Access Compliance Report

Public Rights-of-Way

(Curb Ramps)

Intersection ID: 5912	Main Street: BLACK_CHERRY_DR	Cross Street: FOREST_POND_DR	Location: SW
ADA ID: BE48ED239F03	Ramp Type: Perp	Initial Pass/Fail: Fail	Overall Compliance: No
Severity Score: 21.25			
Codes/Mitigation Info/Possible Solution		Field Measurements/Component Compliance

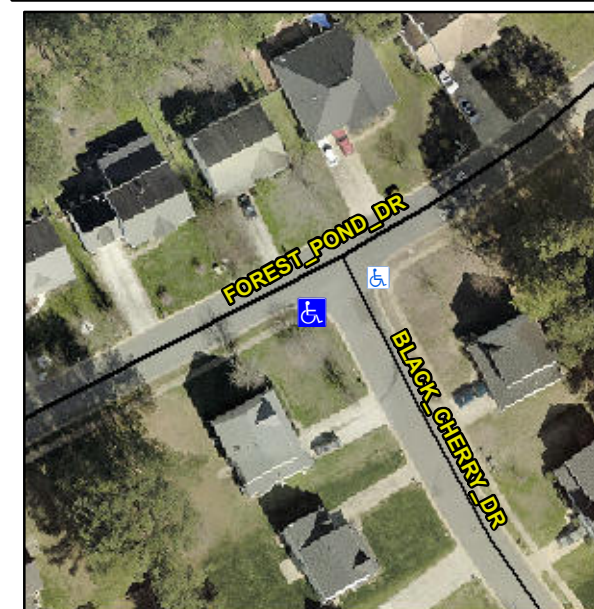
Not Found, R304.5.1, R304.2.2

Compliance	Description	Data	Compliance	Description	Data
N/A	Ramp Length (in)	100.0	No	Ramp Slope (%)	8.4
No	Ramp Width (in)	46.0	Yes	Ramp XSlope (%)	0.5
N/A	Flare Type LT	N/A	N/A	Flare Type RT	N/A
N/A	Flare Slope LT (%)	N/A	N/A	Flare Slope RT (%)	N/A
N/A	Flare Traversable LT?	N/A	N/A	Flare Traversable RT?	N/A
N/A	Landing Length (in)	N/A	N/A	DWS Provided?	N/A
N/A	Landing Width (in)	N/A	N/A	DWS Contrast?	N/A
N/A	Landing Slope (%)	N/A	N/A	DWS Length (in)	N/A
N/A	Landing X Slope (%)	N/A	N/A	DWS Full Width?	N/A
N/A	Landing Curb? (Y/N)	N/A	N/A	DWS Offset (in)	N/A
N/A	Shared Landing?	N/A			
N/A	Gutter Ponding?	N/A	N/A	Gutter Slope (%)	N/A
N/A	Gutter Lip Ht (in)	N/A	N/A	Gutter X Slope (%)	N/A
N/A	Painted X Walk1?	No	N/A	Painted X Walk2?	N/A
	X Walk 1 Direction	To E		X Walk 2 Direction	N/A
N/A	X Walk 1 Width (in)	N/A	N/A	X Walk 2 Width (in)	N/A
	X Walk 1 Slope (%)	0.5		X Walk 2 Slope (%)	N/A
	X Walk 1 X Slope (%)	4.3		X Walk 2 X Slope (%)	N/A

Remove & Replace Entire Ramp.
